ADDENDUM NO. 1

To: All Plan Holders
From: James W. Davidson, P.E., Centurion Planning and Design, LLC.
CC: Steve Harp, Eli Lopez
Date: June 4, 2026
Subject: **Haskell Municipal Airport – Airport Pavement Rehab Bidding; CSJ 2508HASKL, Addendum No. 1**

Attention of all Prospective Proposers/Plan Holders is directed to the following modifications to referenced Plans and Technical Specifications. This Addendum becomes a part of Contract Documents and modifies original Contract Documents dated June 2026. Please find attached the required addendum for the above-mentioned project. Below are the listed changes made.

01 PROPOSED RUNWAY CROSS SECTION
SCALE: N/A

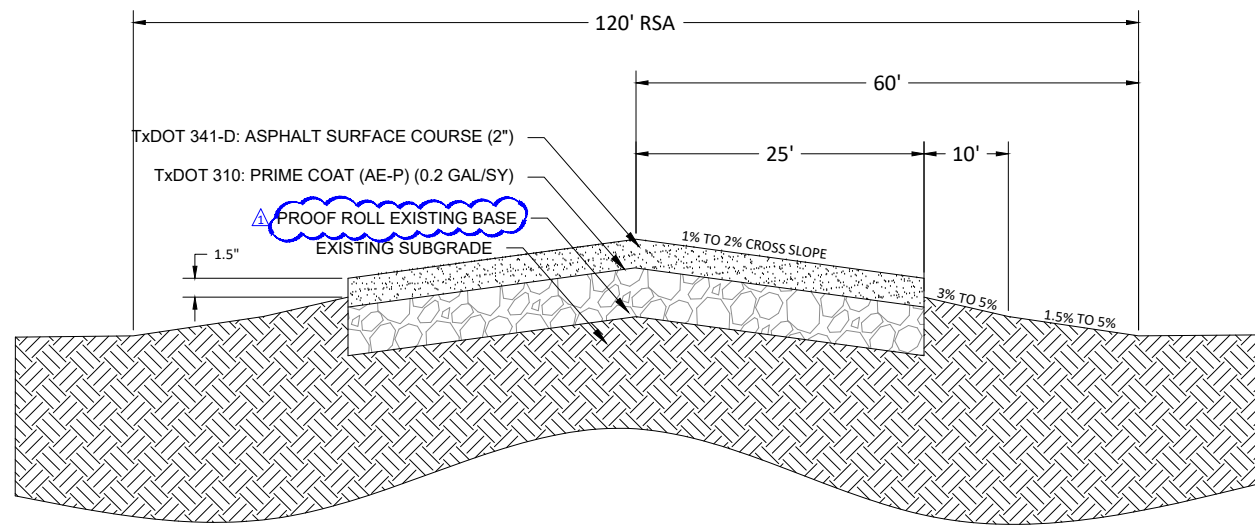
Q2: Per Sheet C-010 detail 01, the cross section shows “Reworked Existing Base (3”-4”)”. Is this to be the entire length of runway, and if so there is currently no pay item for 3”-4” of base work

A2: Reworking of base is only to occur in areas where repair is needed after proof rolling, Plan Sheet C-010 detail 01 has been revised accordingly. Please see revised sheet.

- HMAC SHALL BE TXDOT ITEM 341, TYPE DG-D, COMPACTED TO BETWEEN 92% AND 97% OF THE PAVEMENT'S RICE SPECIFIC GRAVITY. HMAC SHALL HAVE A PERFORMANCE GRADE OF PG 64-22.
- ANY REPAIRS NECESSARY TO THE BASE COURSE, AFTER REMOVAL OF THE EXISTING SURFACE COURSE, SHALL BE PERFORMED THROUGH ITEM TXDOT 351 - FLEXIBLE PAVEMENT STRUCTURE REPAIR AND SHALL UTILIZE COMPACTED BASE / CRUSHED LIMESTONE PER TXDOT ITEM 247, TYPE A, GRADE 1-2 COMPACTED TO AT LEAST 95% STANDARD PROCTOR DENSITY AT A MOISTURE CONTENT WITHIN $\pm 2\%$ POINTS OF THE OPTIMUM MOISTURE CONTENT.
- ENSURE LONGITUDINAL RUNWAY GRADE DOES NOT EXCEED $\pm 2\%$. ENSURE THE GROUND AT THE END OF THE RUNWAY HAS A SLOPE OF 0% TO 3% DOWNWARDS.
- CONSTRUCT A 1.5" \pm 0.5" DROP BETWEEN PAVED AND UNPAVED SURFACES.
